Docket Number: 52-045

Subject: **Request for Additional Information Letter Number 8 Related to Chapter 6 for GE-Hitachi Nuclear Energy Advanced Boiling-Water Reactor Design Certification Rule Renewal Application- GEH Response to RAI 06.03-2, Revision 2**

GEH Revised Response to RAI 06.03-2

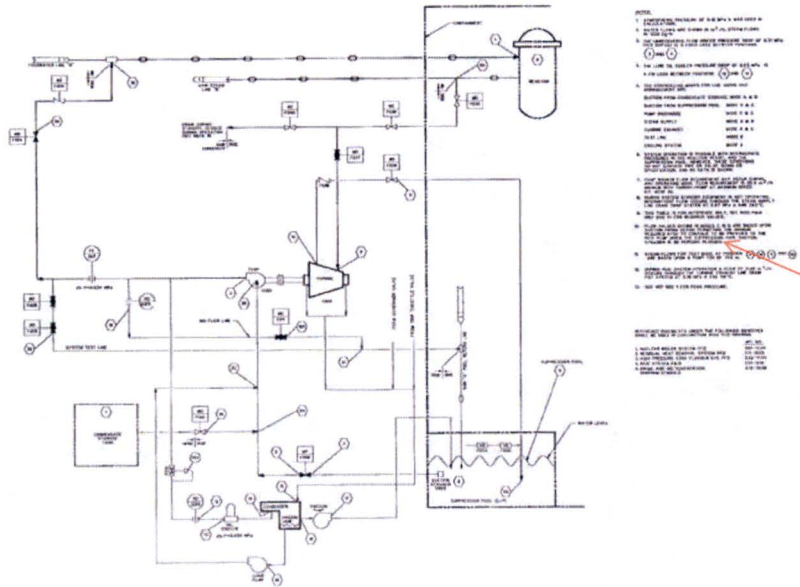
There is also sufficient distance between SRV Discharge Quencher and the ECCS suction filters to prevent steam ingestion into the ECCS Suction Piping (Figure 1.2-13i).

Tier 1, Tables 2.4.1, 2.4.2 and 2.4.4 (ITAAC) include a requirement for the respective ECCS pump suction Strainer for a verification of adequate vertical and horizontal separation between the ECCS suction strainer and the SRV quencher to prevent the potential effect of air and or steam ingestion. **The acceptance criterion is based on Figure 1.2-13i.**

Therefore, Issue 193 is resolved for ABWR **with the addition of the ITAACs for verification of the distances in the as-built conditions.** ~~actions identified for the COL~~

Figure 5.4-9 Reactor Core Isolation Cooling System PFD (Sheet 1 of 2)

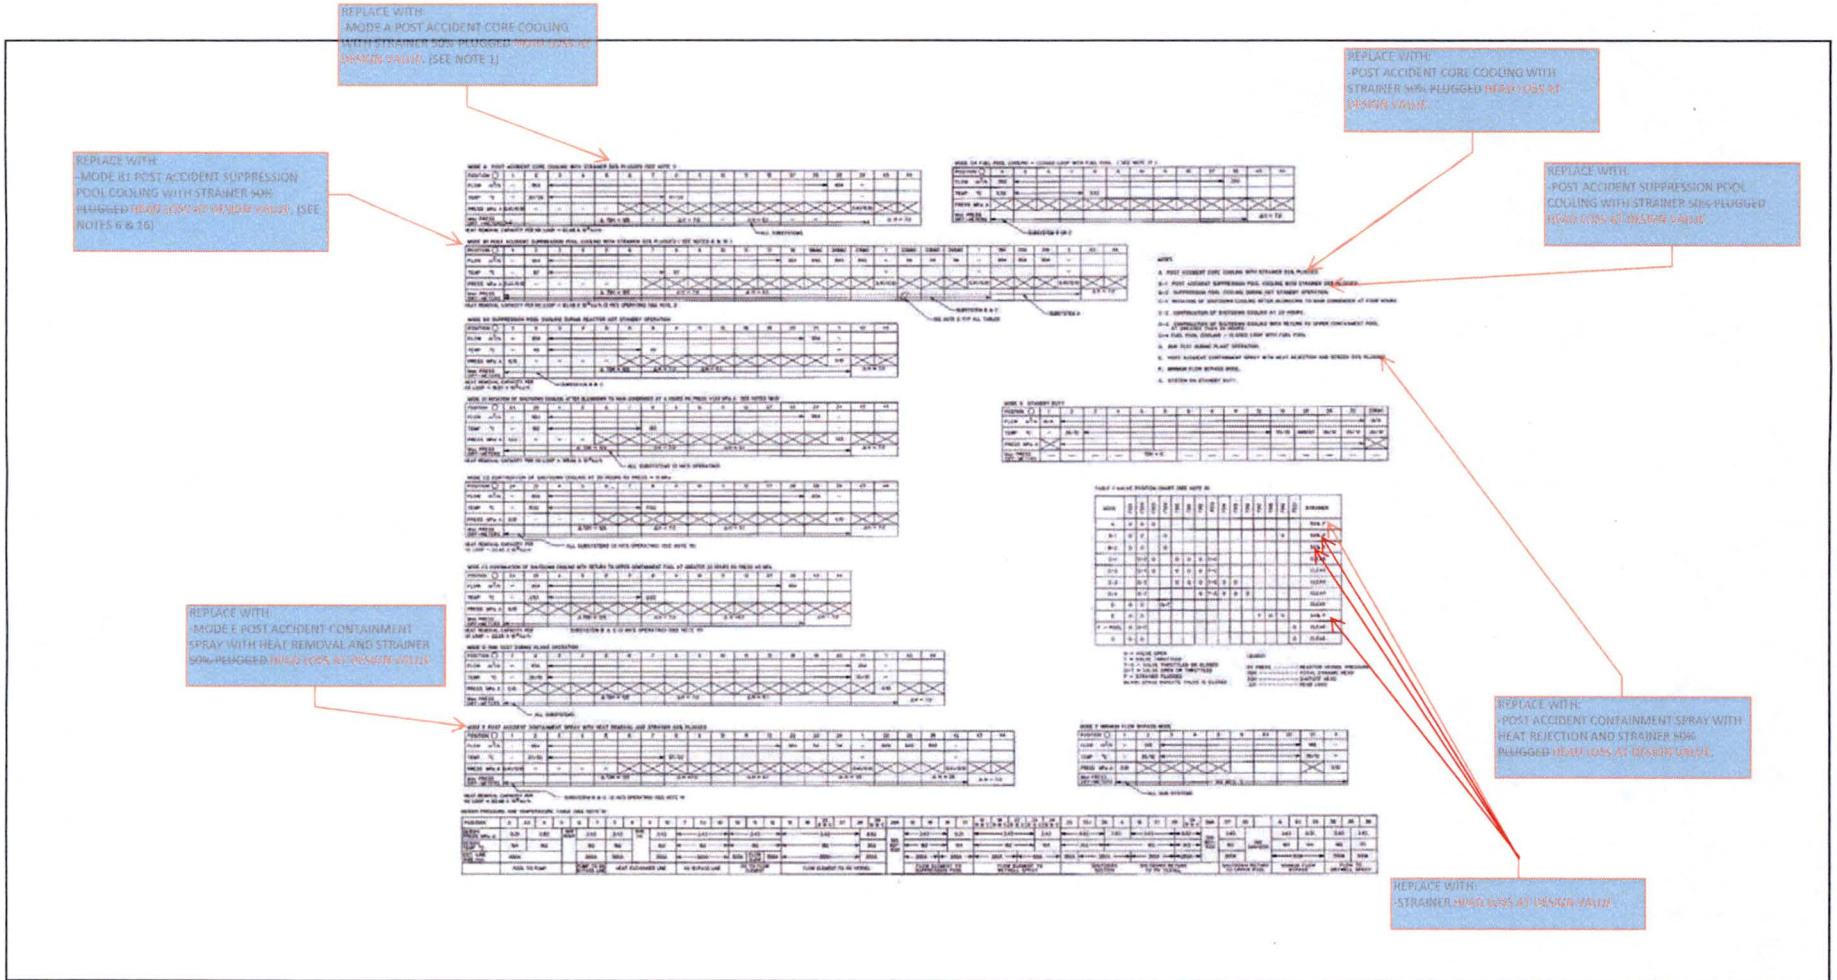
- Figure 1.2-13i Updated wetwell arrangement plan to reflect GE stacked disk strainer design that supersedes the T-type conical strainer design (Chapter 21, Volume 1; contains security-related information)
- Figure 5.4-9 (Sh. 1 of 2) Note 10- Replaced requirement for 50% blockage of RCIC suction strainer with strainer head loss at design value
- Figure 5.4-11 (Sh. 2 of 2) Numerous entries- Replaced requirement for 50% blockage of RHR suction strainer with strainer head loss at design value

REPLACE WITH THE FOLLOWING:

10. FLOW VALUES SHOWN IN MODES C & D ARE BASED UPON SUCTION PIPING DESIGN PERMITTING THE MINIMUM REQUIRED NPSH TO CONTINUE TO BE PROVIDED TO THE RCIC PUMP WHEN SUPPRESSION POOL SUCTION STRAINER IS 50 PERCENT PLUGGED HEAD LOSS IS AT THE DESIGN VALUE
